SAFETY CASE REPORT

ADDENDUM

Tihange 2

Reactor Pressure Vessel Assessment

Figure 2.1: Size of the largest flaws with 20° inclination potentially not reported by UT inspection

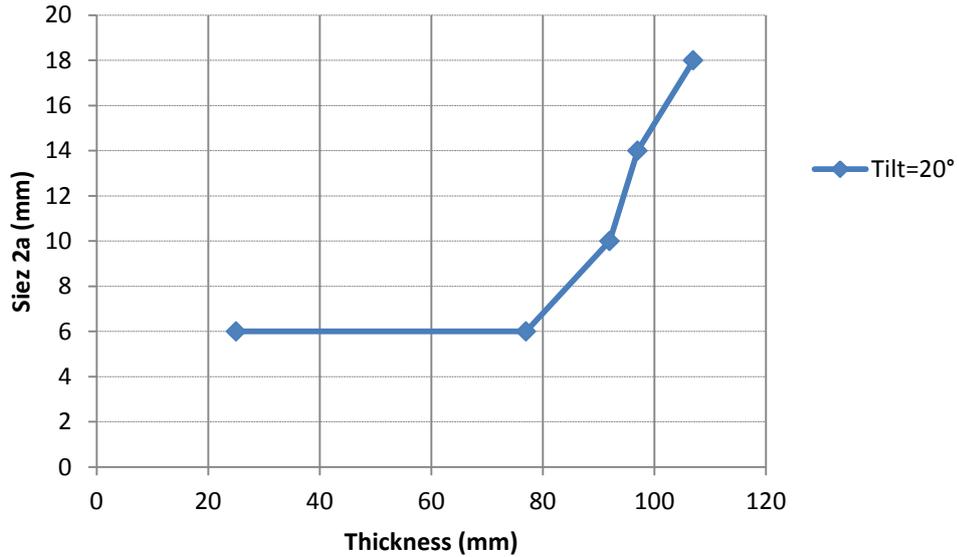
The licensee shall demonstrate that the applied ultrasonic testing procedure allows the detection of the higher tilt defects in the Doel 3/Tihange 2 data (2012 inspections) with a high level of confidence.

For the depth range between 25 and 120 mm, Figure 2.1 shows the size of the largest flaw with the conservative 20° inclination that would potentially not have been reported, as a function of the position in the RPV wall. The impact that these potentially unreported flaws could have on the results of the Structural Integrity Assessment (SIA) is addressed as part of the Sensitivity Analyses in Chapter 5.

Flaws with an inclination up to 20°—that would potentially not have been reported—have been determined as a function of the position in the RPV wall. These potential flaws are considered in the Structural Integrity Assessment as part of the Sensitivity Analyses (see Chapter 5).

Figure 3.1: Factors contributing to the creation of hydrogen flakes

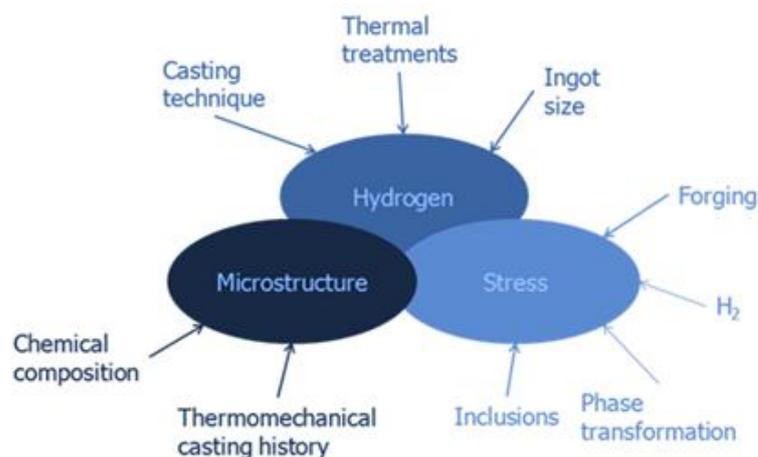
During the discussion of the Safety Case Report, it was noted that the root cause analysis did not explain why the hydrogen-induced degradation did not evenly affect all the forged components of the Doel 3 and Tihange 2 RPVs, though their hydrogen content is comparable.

The results of the analysis show a good correlation between susceptibility levels and actual presence of flakes: the most affected forgings indeed fall in the high susceptibility category.

Figure 5.2: Flaw-screening criterion applied to core shells of Tihange 2

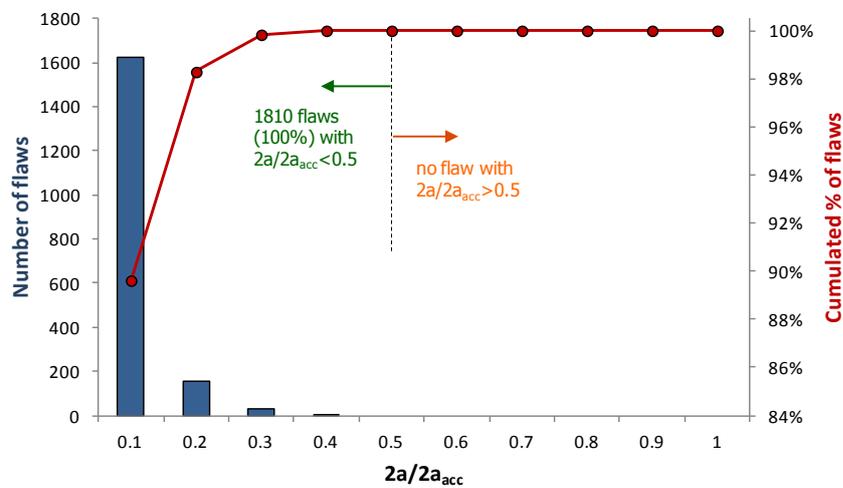
To assess the effects of the high number of detected flaws, Bel V proposed to use a deterministic screening criterion approach. The objective of this approach is to show:

Applying the flaw-screening criterion to the flaws detected in the RPV core shells of Tihange 2 shows that none of the flaws exceed the flaw-screening criterion, as illustrated here:

Figure 5.3: Sensitivity analysis for S→0 combined with effect of a 5° increase of the inclination of the Doel 3 flaw (Ev2220)

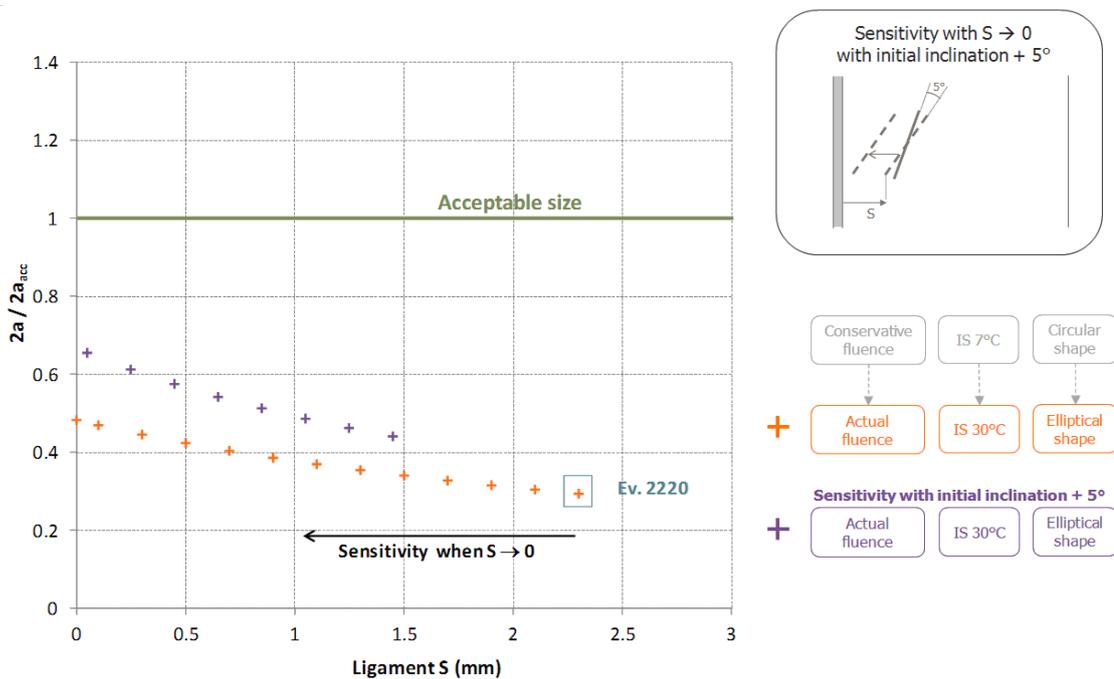
The International Expert Review Board (IERB) required a sensitivity analysis for the location of the flaws in the structural analysis. More specifically, the IERB suggested considering the most critical flaw of the analysis (the Doel 3 flaw Ev2220, with the corresponding Stress Intensity Factor (SIF) of 30.9 MPa√m) and to investigate how the results of the SIA change when the flaw's ligament S would tend to zero.

A number of sensitivity analyses were performed on the most penalizing flaw of the two RPVs (Doel 3 flaw Ev2220), considering effects such as the ligament tending to zero, a 5° larger inclination, the actual fluence, the flaw shape, and the Safety Injection water temperature. Results confirm that a significant margin remains in all cases. This figure shows the evolution of the margin with respect to the acceptability criterion with the ligament S tending to zero.

Figure 5.4: Size of largest potentially unreported higher tilted flaw (20° tilt)

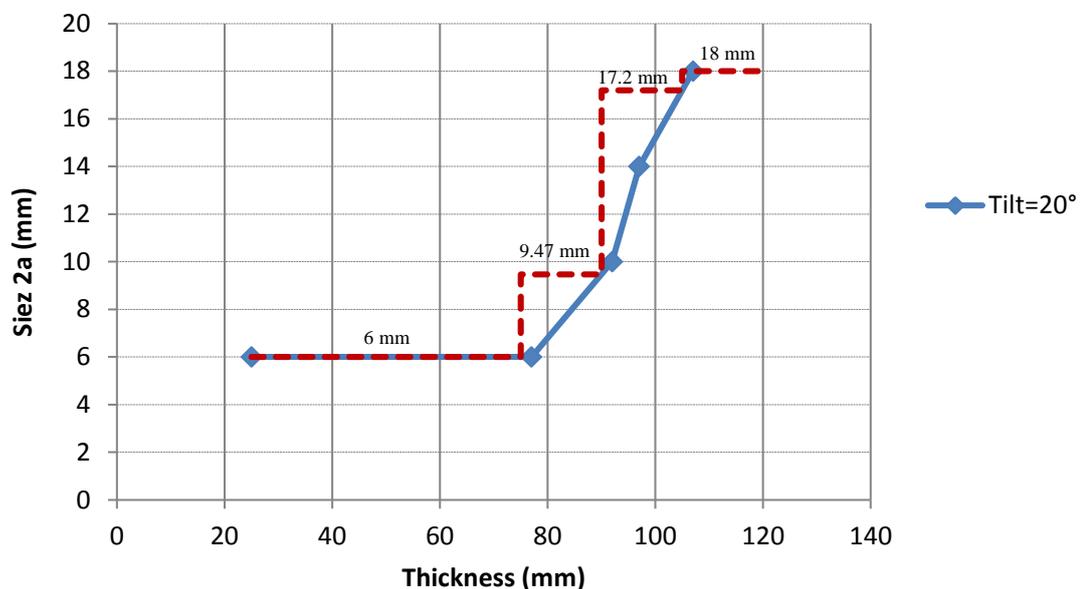
Chapter 2.1.5 of this addendum, Potentially Unreported Higher Tilted Flaws, addresses the question of flaws that could potentially be present in the RPV wall, but would not have been taken into account in the structural integrity analysis. This is because the amplitude of their UT response would have been below the reporting level applicable during the 2012 UT inspections of the Tihange 2 RPV.

- The depth range of 25-120 mm is divided into four intervals. For each interval, a bounding maximum flaw size is conservatively determined, as illustrated in Figure 5.4 by the red dashed line. All potentially unreported flaws in a particular interval are given the maximum inclination of 20°.
- In total, 282 potentially unreported flaws were considered. They have been distributed into the shell similar to the reported flaw distribution.
- Finally, the Flaw Acceptability Analysis, as outlined in Chapter 5.2, was performed on the entire population of reported and potentially unreported flaws.
